COLLEX602 BUYER MARKED PLAN

DOGWOOD **REVISION LIST - STRUCTURAL:**

09/09/2024 - Buyer Selection Notes Added

First Floor Plan SCALE: 1/4"=1'-0" ON 22x34 AND 1/8"=1'-0" ON 11x17

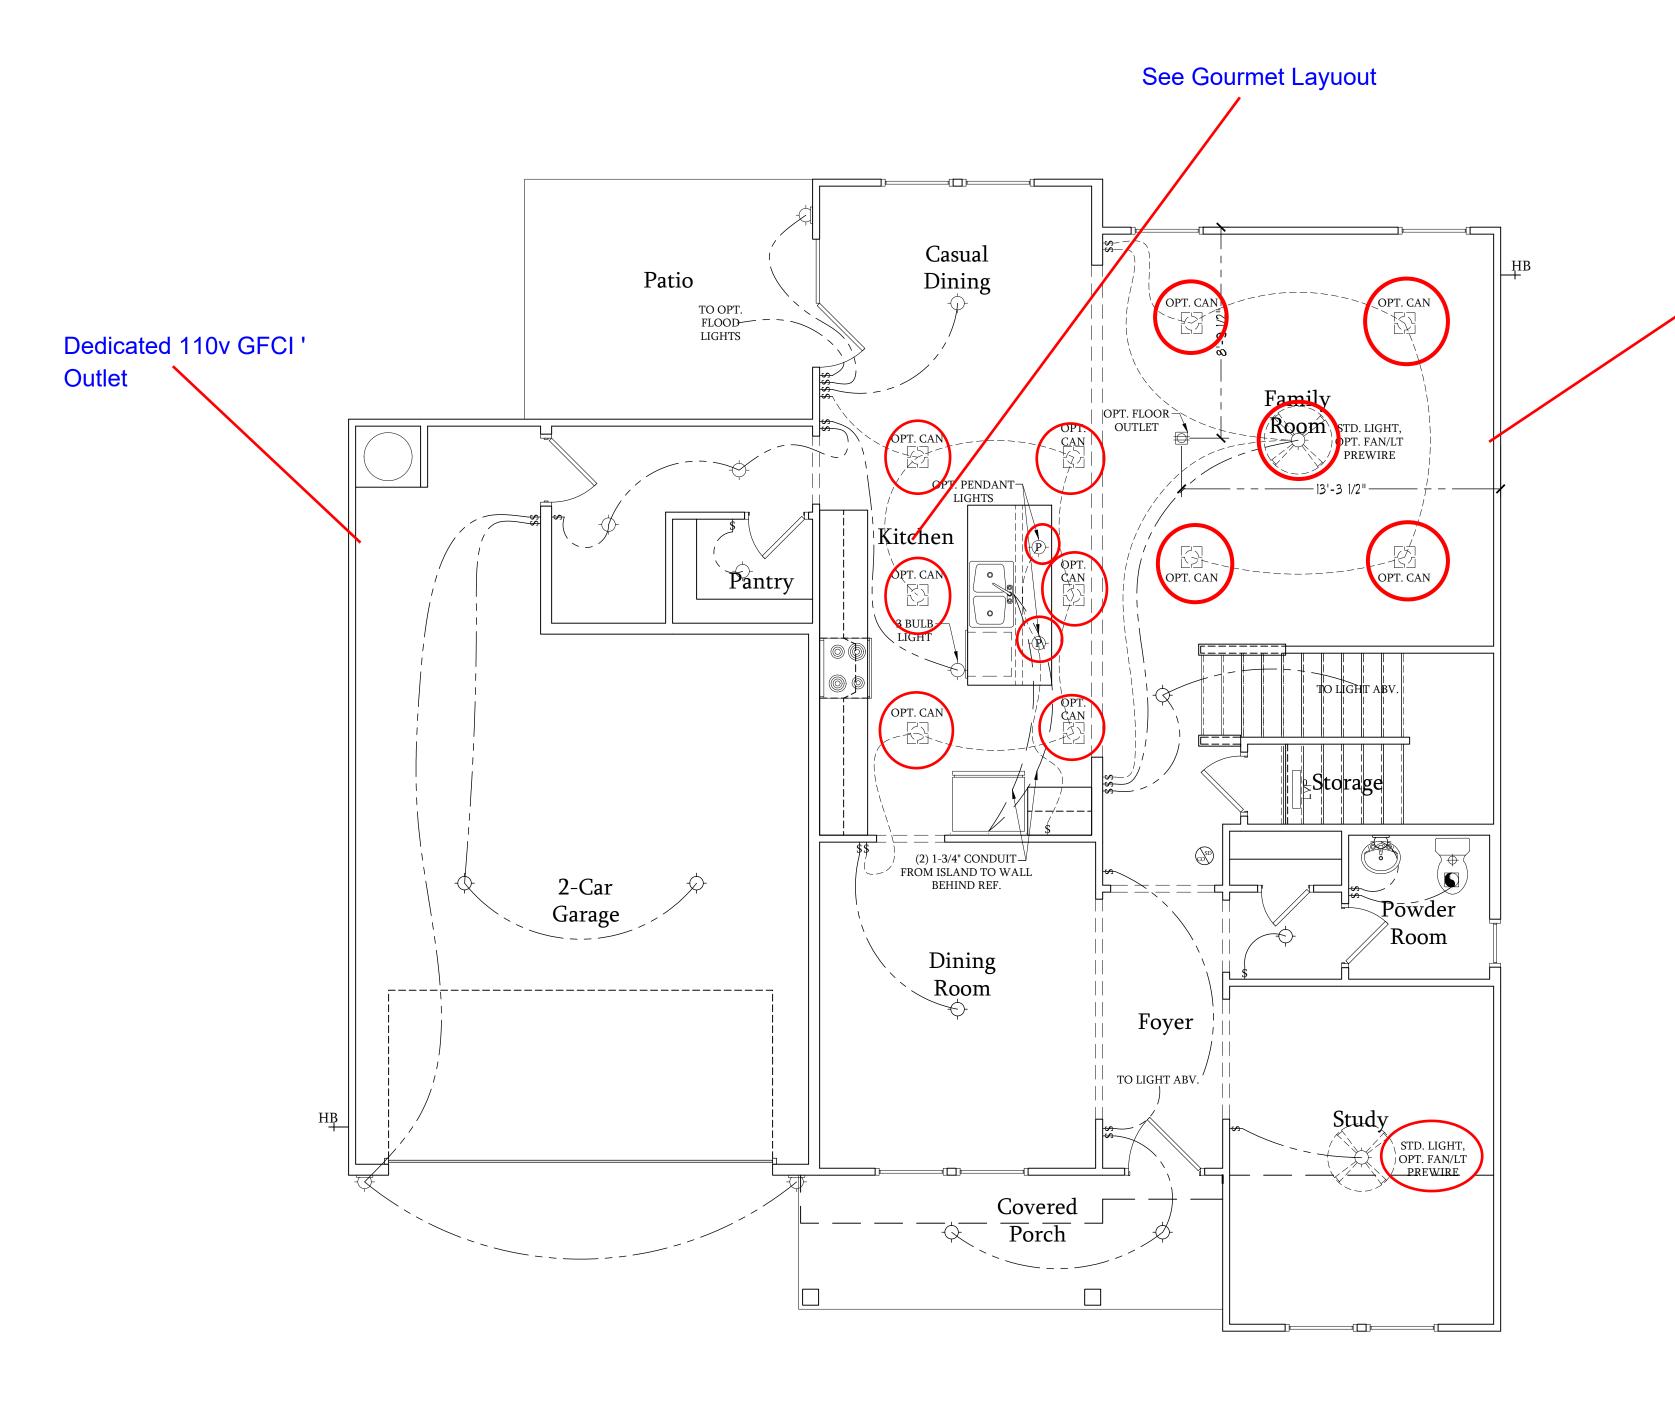
110v Outlet @ 65" (w/ LV Connections)
